### **Meadowbank 2022 Annual Open Pit Geomechanical Inspection**

**RE: Meadowbank Complex - Meadowbank Site - 2022 Annual Open Pit Geomechanical Inspection**

### **Meadowbank Complex - Meadowbank Site - 2022 Annual Open Pit Geomechanical Inspection**

August 12 to 14, 2022

Looking Northwest at the Dump, with Settlement and Scarps Visible

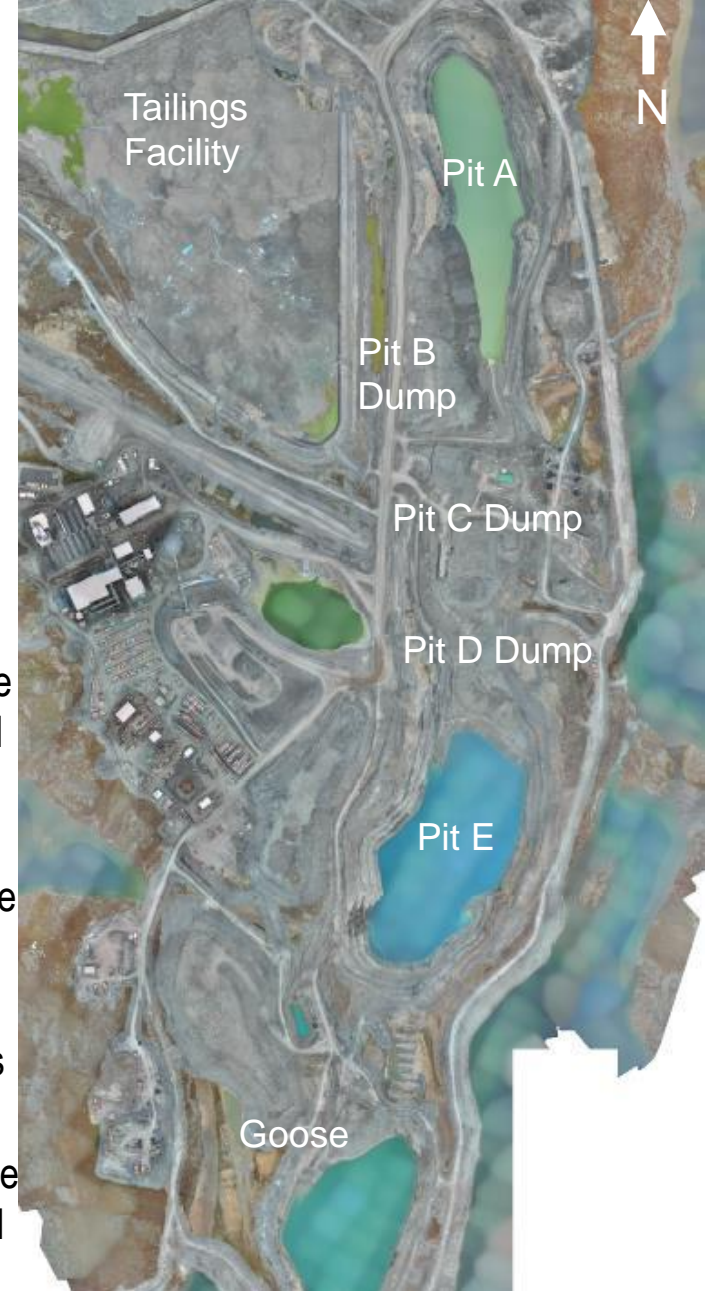
- The dump has been subsiding since 2015. The settlement is attributed to the deposition of water in the open pit, through a combination of thawing snow/ice lenses within the dump, thawing frozen contacts between rock blocks, and increasing porewater pressure. An example of one of the scarps formed by the settlement is shown at lower right.
- The settlement is monitored visually as part of monthly inspections by the Geotechnical team.
- The dump is inactive and access is prevented by both a rockfill berm and the presence of water pipes across the access point.
- Recommend continuing the monthly visual monitoring as long as access is still required to the open pit. There is a need to better quantify the extents and rate of deformation. Survey pins, extensometers or drone photogrammetry are possible options.

South Ramp, Looking North with PTO/Pump Controls at Left

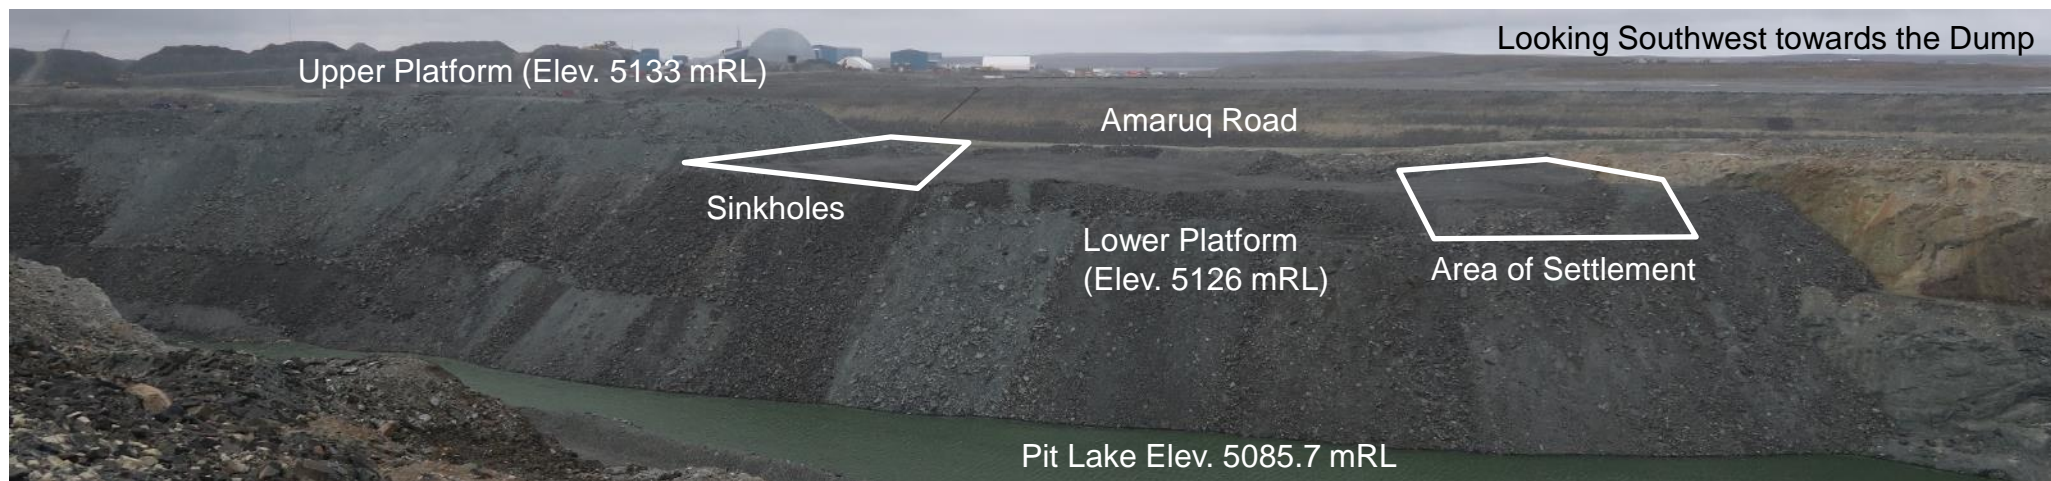
- The south ramp is used to access the pit lake and water management infrastructure is present along the ramp.
- A rockfall berm is present along both sides of the ramp. The berm is in good condition and has capacity to retain any future rockfall.
- The PTO / Pump controls are located well up the ramp, away from the areas of greatest rockfall hazard associated with the dump and the highwall. The controls are also well away from the pit lake, mitigating the risk associated with a wave caused by a failure of the open pit slope or the dump. This is a good practice.
- Specific geotechnical considerations relating to Dump B are discussed on the next slide. Bulging of the toe of the dump slope was not observed.
- No particular geomechanical concerns were noted.

2014 Construction of Dump B, looking Southwest

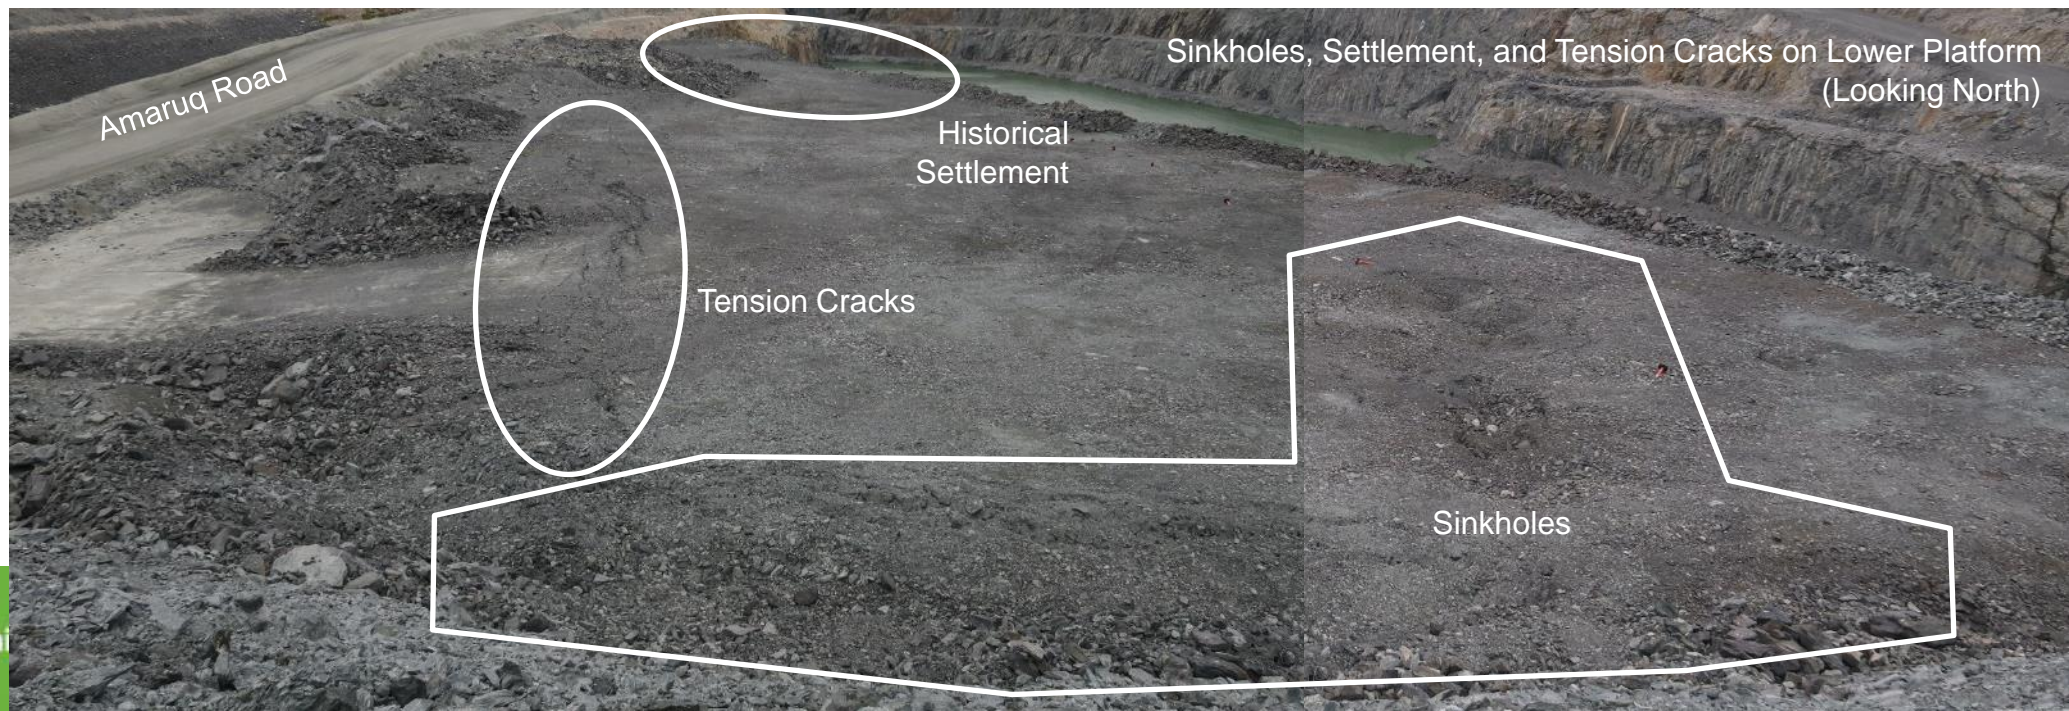
- The potential for a failure of the dump back towards the Amaruq Road was identified in 2021 as it was not clear if the road is partially constructed on the dump.
- Further discussions in 2022 and photos provided by AEM during construction of the dump in 2014 and 2015 suggest that the portion of the dump closest to the road is founded on the Pit A ramp and a failure of the dump would not extend back to the Amaruq Road. It is understood that SNC Lavalin is completing a detailed review.

C Dump, Looking East

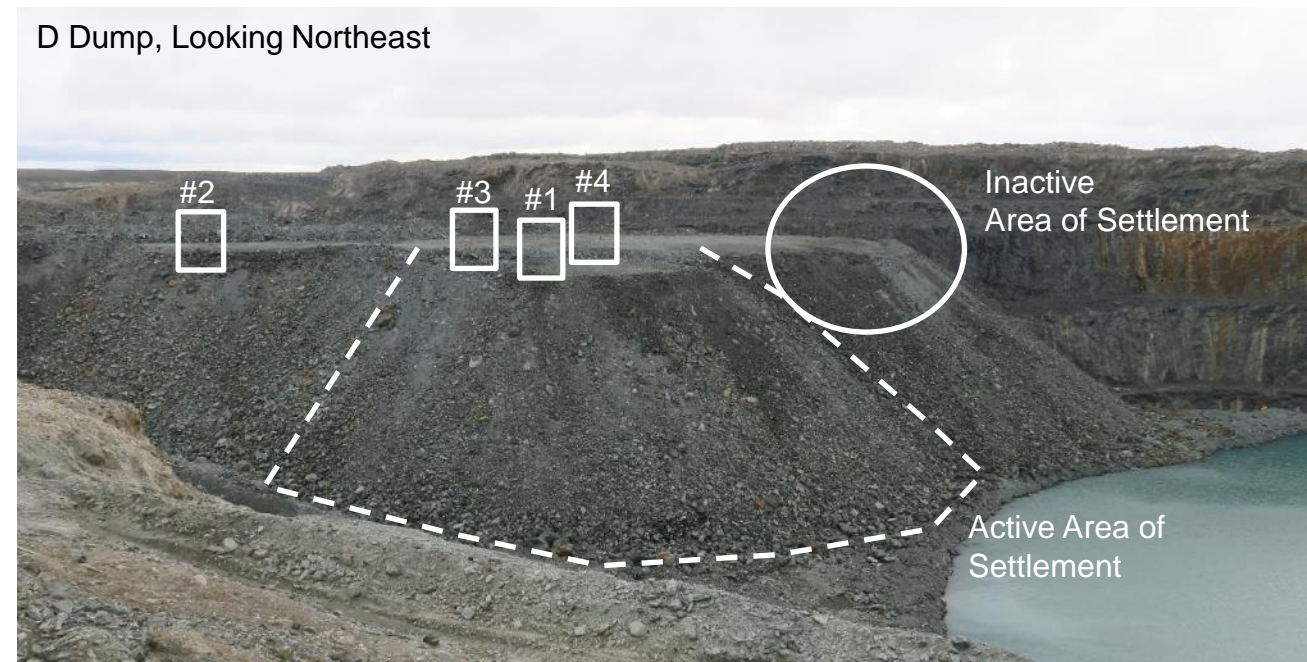
- The ABF Garage was constructed on the C Dump platform in 2020, approximately 35 to 45 m from the crest of the dump. As the water elevation in Pit A and the water/tailings elevation in Pit E reach and surpass the base of the dump, settlement of the dump is expected.

- The ABF Garage is currently in the process of being dismantled and moved off of the dump. This is endorsed.
- The seacan used to provide power to the Pit A pumps is inside the berm constructed along the crest and should be moved outside of the berm.

- As no evidence of instability has been observed, the on-going use of the dump as a laydown is considered acceptable (at least for now).

Tension Cracks at  
Crest by  
Extensometer #2,  
Looking North

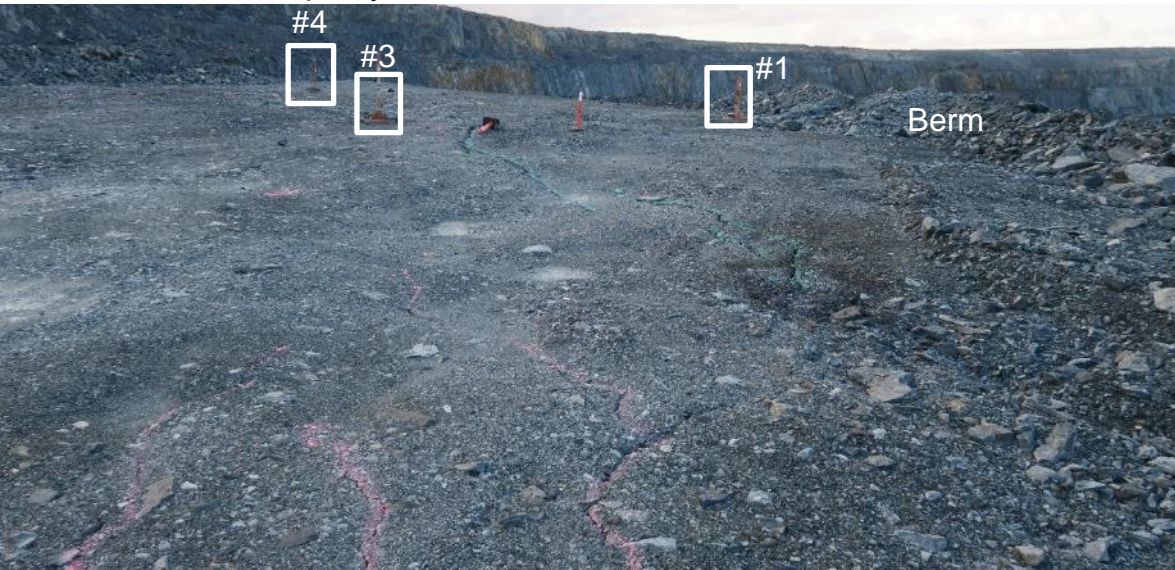
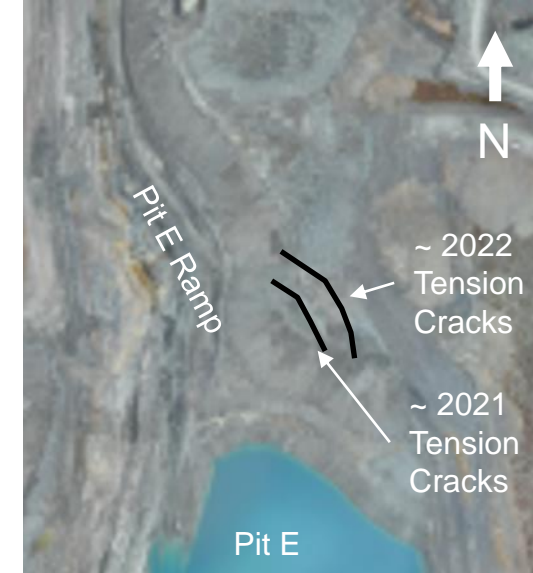
- The north end of the dump is adjacent the Pit E Northwest ramp. Tension cracks previously formed along the crest of the dump in this area. There has been limited change in the tension cracks since the 2020 inspection and bulging of the toe of the slope was not observed.

- Seepage was observed at the toe of the dump in this area for the first time during this inspection. The seepage is clear. The source has not been confirmed, but is speculated to be water from the East Dyke that is discharged into Dump C and flows through the dumps. The seepage should be monitored.

- Wireline extensometer #2 was installed at the crest of the dump in the area of the tensions cracks in 2019. The extensometer is monitored monthly. The data are discussed later in this presentation but the deformation rate is currently less than 1mm/day.

- The monitoring and the monthly visual inspections should continue while access to the Pit E Northwest ramp is still required.

Tension Cracks on Dump, Looking Southeast

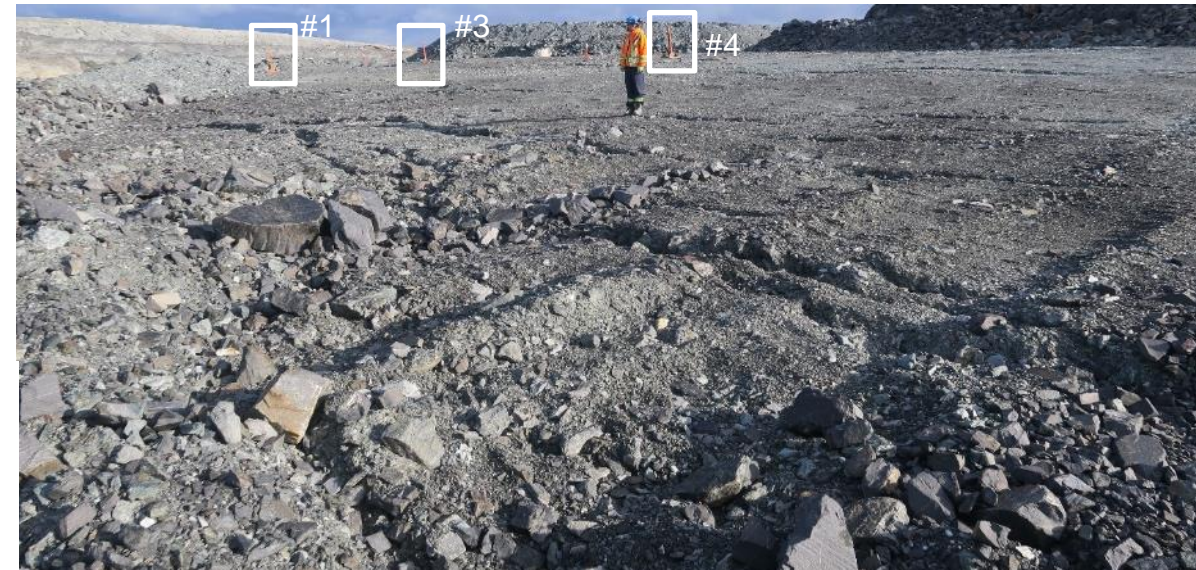
- Deformation and settlement of the southwest corner of the dump has been on-going since 2017. This was previously restricted to a small portion of the dump. A berm was installed to restrict access and Extensometer #1 was installed to monitor the deformation.

- Since the 2021 inspection, a network of tension cracks have developed 10 to 20 m behind Extensometer #1. Extensometers #3 and #4 have been installed behind the most recent tension cracks. The extensometer data is discussed on the next slide.

- The Geotechnical Group has been painting the cracks to track their change over time. This is endorsed and should continue.
- The tension cracks suggest that the direction of movement is to the southwest (i.e., towards the point where the Pit E Ramp terminates in the pit lake) rather than to the south, directly towards the pit lake. The reason for this is not currently known.

- On-going deformation of the dump could result in a rockfall hazard to the ramp. A berm is currently in place at the toe of the dump but its capacity and evidence of rockfall should be monitored.

## D Dump - Extensometers

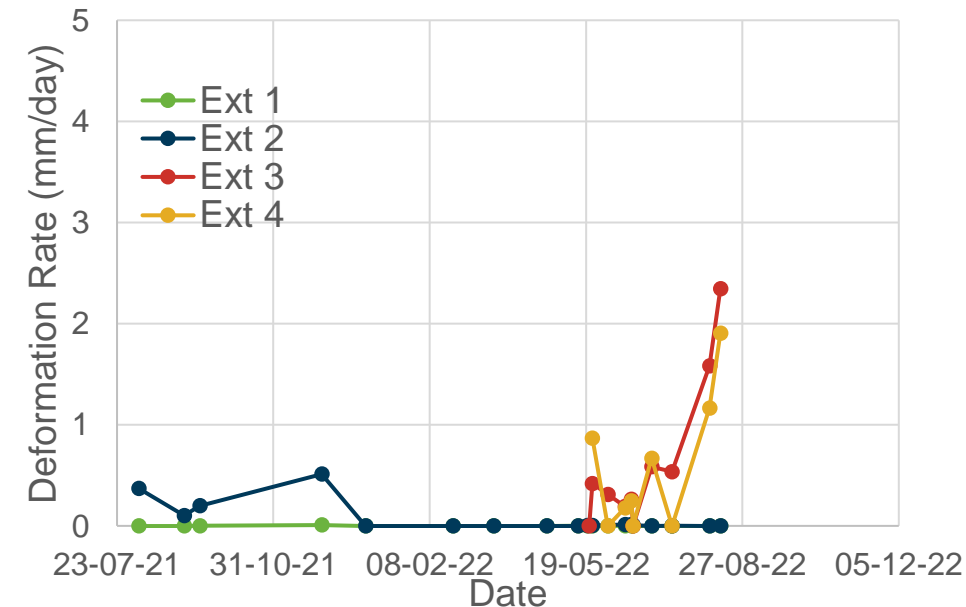
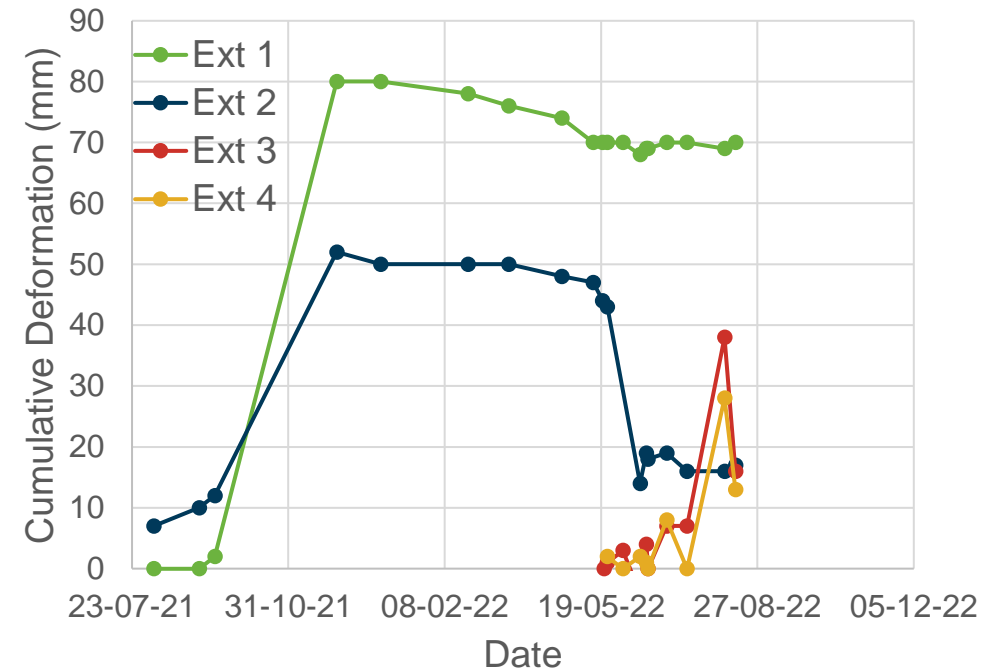
- Both Ext 1 and 2 reported a significant increase in displacement in December 2021. No action was taken and the cause is unknown. While the deformation rate was less than the trigger of 50 mm/day, the sudden change in rate should have triggered a review.

- Observations suggest that the extents of the displacement zone have now extended beyond Ext 1 and it is only capable of measuring relative displacement within the deforming volume. The extensometer was relocated during the inspection.

- Both Ext 3 and 4 are reporting a steady increase in deformation rate as of June, 2022. This suggests a change in conditions and readings should continue to be collected every two weeks until the deformation stabilizes or the slope behaviour is better understood.

- In all cases, the current rate of <5 mm/day is much less than the 50 mm/day threshold that would trigger a response under the procedure. Continue monitoring the extensometers.

Lower Ramp, with Pumps, Looking Southwest

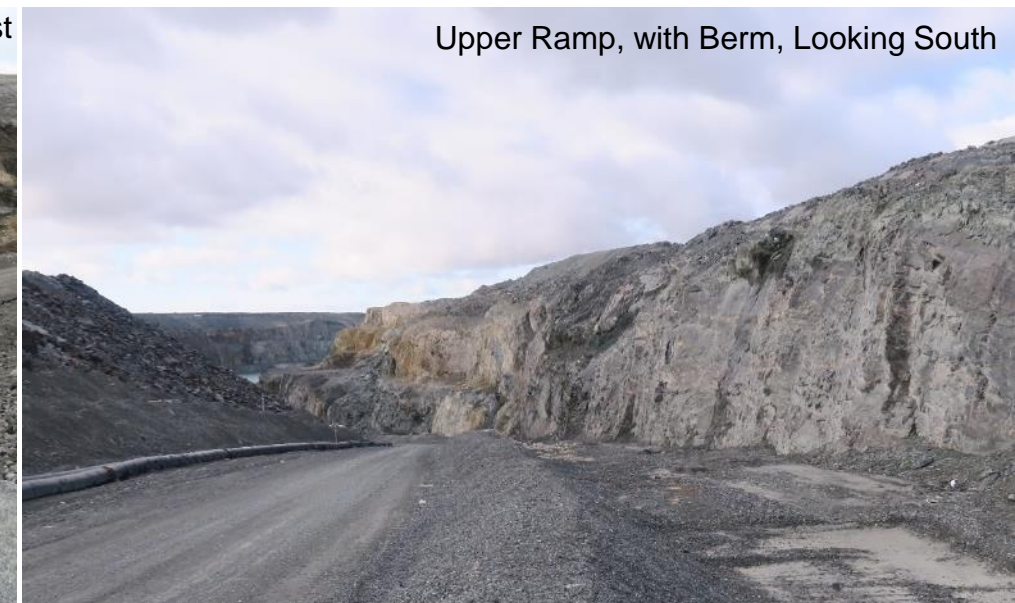
- A rockfall berm was previously constructed and has been effective at managing rockfalls. The capacity of the berm reduced over time and a second berm was constructed in 2021 further away from the wall. The two berms appear suitable to retain most rockfalls, but it is still possible that they could be overtopped in some circumstances. Geotechnical inspections of the area should continue while access to the ramp is still required.

- The water management infrastructure is located on the outside of the ramp, which effectively reduces exposure. However, in the future it will need to be relocated further up the ramp, below some of the current rockfall hazards. Exposure to personnel and equipment will need to be re-assessed at that time.

### Area 3 (Looking North)

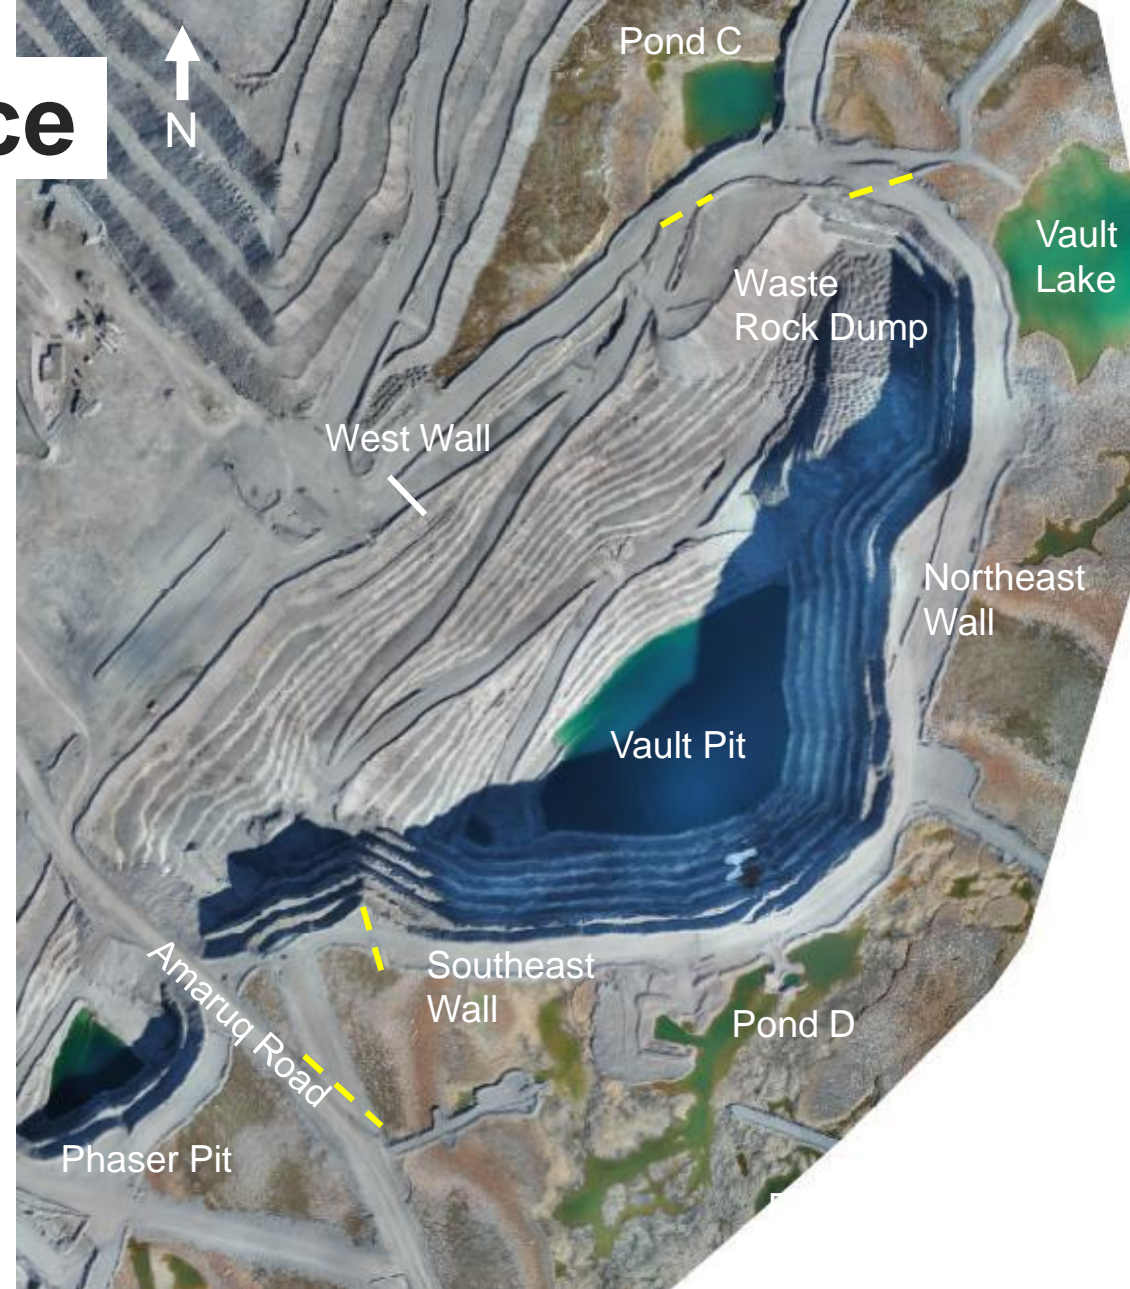
- A potentially dilating slab block was identified along the contact of the fault zone and represents a rockfall hazard.
- The block has the potential to overtop the rockfall berm and should continue to be monitored.
